Memorandum

Date: November 4, 2024

Re: **WBP Development LLC - 1 Croton Point (aka Lot A)**
WBP Development LLC (Applicant)

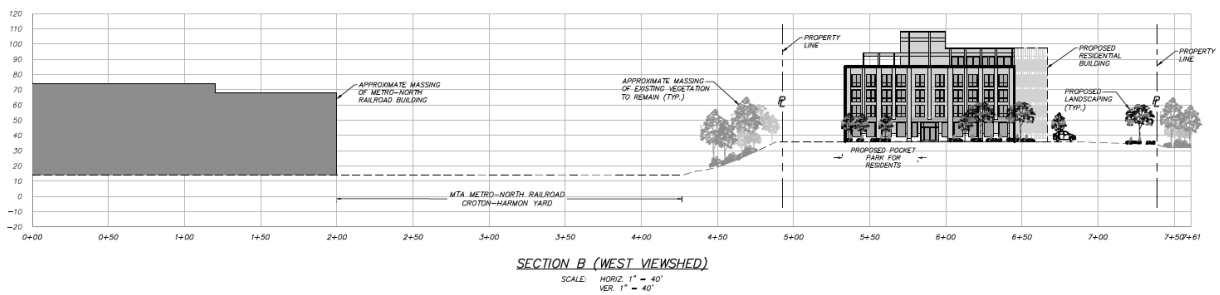
1. 10/4/24: The PSAC memorandum now states on page 3 that the updated 2023-2025 CHUFSD local multifamily study resulted in a multiplier of 0.25 students per unit, but the table on top of page 4 continues to present the 0.20 rate and resulting 20 students. This table should be updated to match the text.

11/4/24: The table in question was corrected to match the text as part of the Applicant’s revised PSAC Analysis dated October 16, 2024. No further comment.

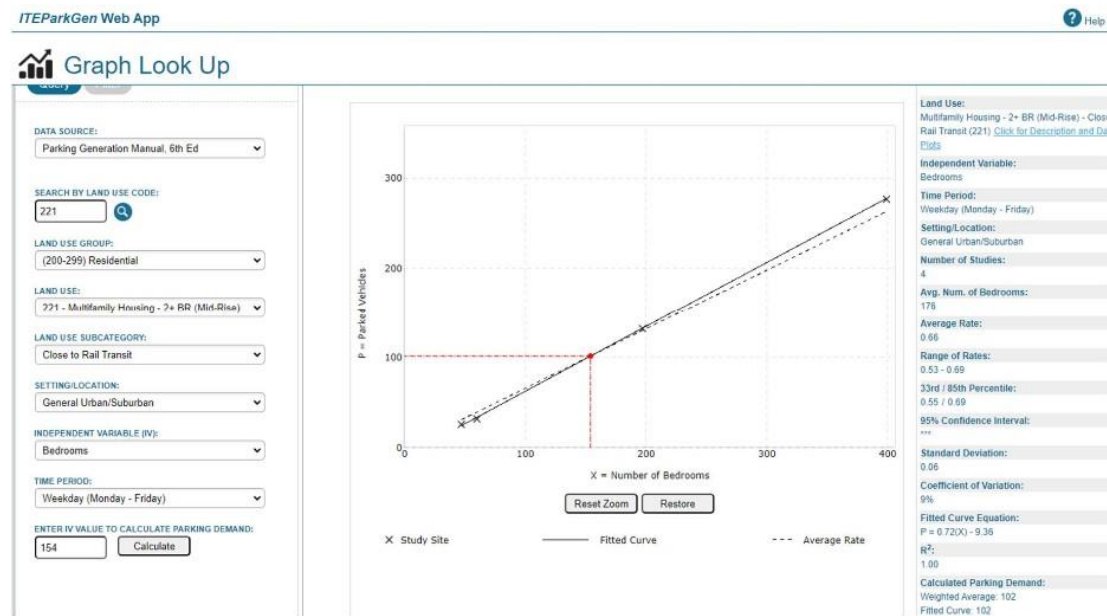
8. AKRF 10/4/24: The parking demand calculations were based on ITE data for ITE Land Use 223 (“Affordable Housing”). These calculations should be revised to be based on ITE Land Use 221 (“Multifamily Housing – Mid-Rise”) so that they are consistent with the Land Use utilized to develop the trip generation traffic volumes. These changes should be incorporated into the revised TIS. The Village Manager noted that the number of current parking spaces in Lot A are 122 spaces, not 134. This number should be verified and the revised TIS should update any references to the current capacity of Lot A accordingly.

Applicant Response: While the project is an affordable housing development which has its own category in the ITE, for consistency, Kimley-Horn calculated parking demand based on ITE Land Use Code (LUC) 221. The project has 100 units with 154 bedrooms. Based on the ITE LUC 221, which is located close to rail, and using bedrooms as the independent variable, the parking demand will be 102 vehicles. The project has 105 parking proposed spots which satisfies the demand. Please see the image below for details.

AKRF 11/4/24: Comment addressed. The parking demand of 102 vehicles based on the ITE LUC 221 (located close to rail) is based on utilizing bedrooms, not units, as the independent variable. It is noted that the number of parking spaces provided also meets the zoning requirement.
